# Access Compliance Report

## Public Rights-of-Way

Intersection ID: 12186	Main Street: E_11TH_ST	Cross Street: E_BROOKSHIRE_FR_RA	Location:	N
ADA ID: 8D13124D94F8	Ramp Type: Perp	Initial Pass/Fail: Fail	Overall Compliance: No	Severity Score: 10

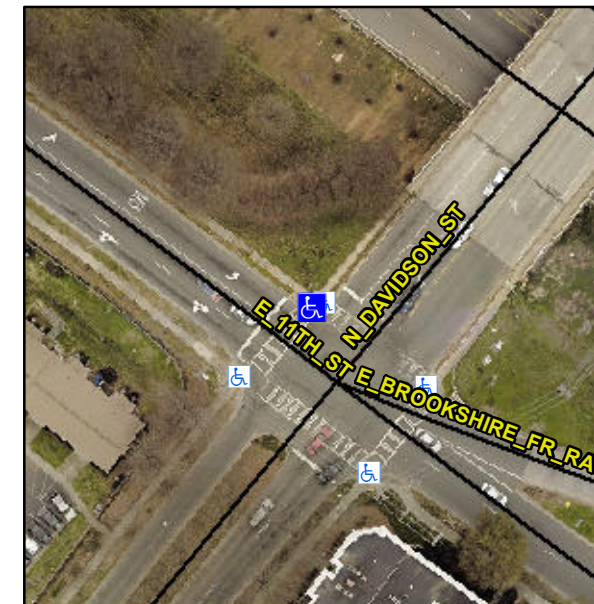
**Not Found, R304.5.1, R304.5.3**

Compliance	Description	Data	Compliance	Description	Data
N/A	Ramp Length (in)	43.0	Yes	Ramp Slope (%)	2.3
No	Ramp Width (in)	46.0	No	Ramp XSlope (%)	4.4
N/A	Flare Type LT	N/A	N/A	Flare Type RT	N/A
N/A	Flare Slope LT (%)	N/A	N/A	Flare Slope RT (%)	N/A
N/A	Flare Traversable LT?	N/A	N/A	Flare Traversable RT?	N/A
N/A	Landing Length (in)	N/A	N/A	DWS Provided?	N/A
N/A	Landing Width (in)	N/A	N/A	DWS Contrast?	N/A
N/A	Landing Slope (%)	N/A	N/A	DWS Length (in)	N/A
N/A	Landing X Slope (%)	N/A	N/A	DWS Full Width?	N/A
N/A	Landing Curb? (Y/N)	N/A	N/A	DWS Offset (in)	N/A
N/A	Shared Landing?	N/A			
N/A	Gutter Ponding?	N/A	N/A	Gutter Slope (%)	N/A
N/A	Gutter Lip Ht (in)	N/A	N/A	Gutter X Slope (%)	N/A
N/A	Painted X Walk1?	Yes	N/A	Painted X Walk2?	N/A
	X Walk 1 Direction	To SW		X Walk 2 Direction	N/A
N/A	X Walk 1 Width (in)	120.0	N/A	X Walk 2 Width (in)	N/A
	X Walk 1 Slope (%)	3.0		X Walk 2 Slope (%)	N/A
	X Walk 1 X Slope (%)	3.7		X Walk 2 X Slope (%)	N/A

**Remove & Replace Entire Ramp.**
